UNITED STATES PATENT AND TRADEMARK OFFICE

| APPLICATION NO. | FILING DATE | FIRST NAMED INVENTOR | ATTORNEY DOCKET NO. | CONFIRMATION NO. |
|-----------------|-------------|----------------------|---------------------|------------------|
| 10/594,916 | 09/29/2006 | Tomohiro Yabu | 4633-0186PUS1 | 5517 |

| Office Action Summary | Application No. 10/594,916 | Applicant(s) YABU ET AL. | |

DETAILED ACTION

【図1】

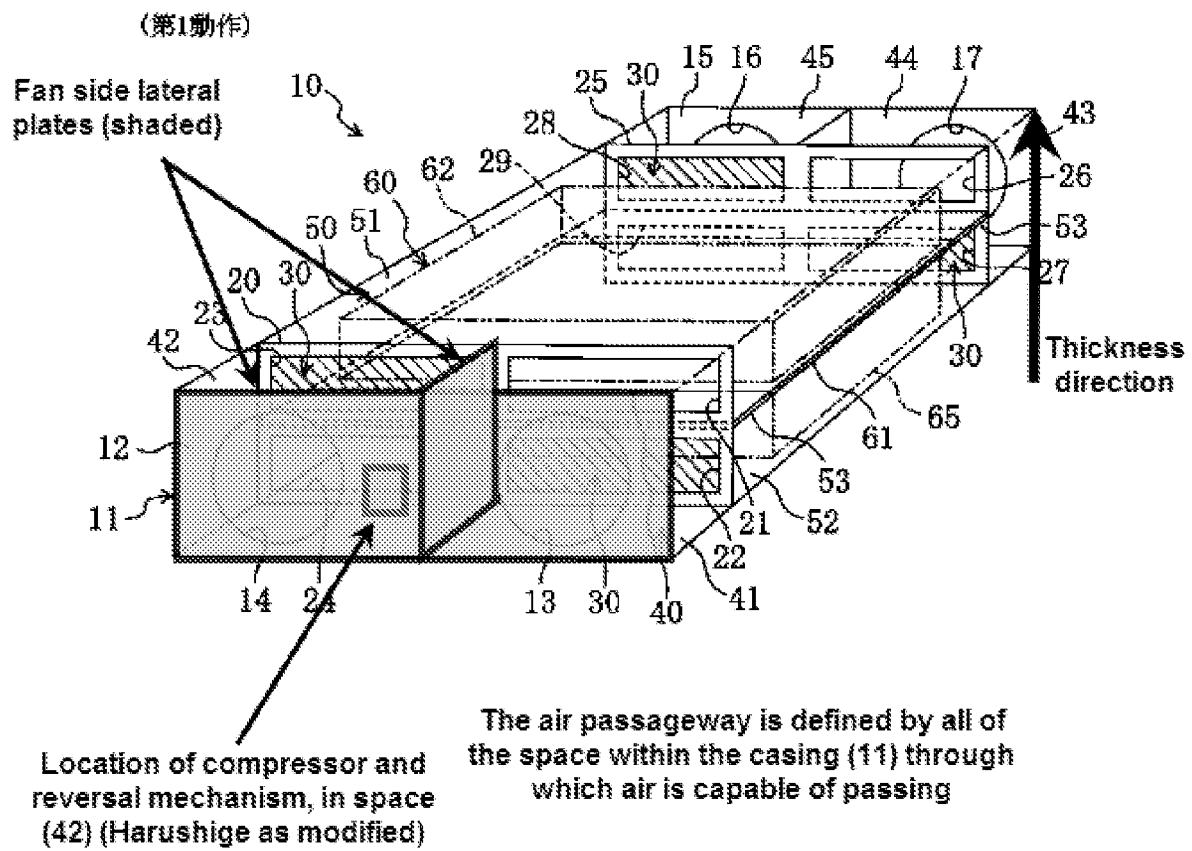
Consider claim 19. Harushige discloses that in the casing (11) the first and second heat exchangers (62) & (65), respectively, are disposed adjacently to each other and the inflow surface of the first heat exchanger (62) and the inflow surface of the second heat exchanger (65) lie on the same plane, wherein the same plane is perpendicular to the fan side lateral plate (annotated Fig. 1; Fig 2).
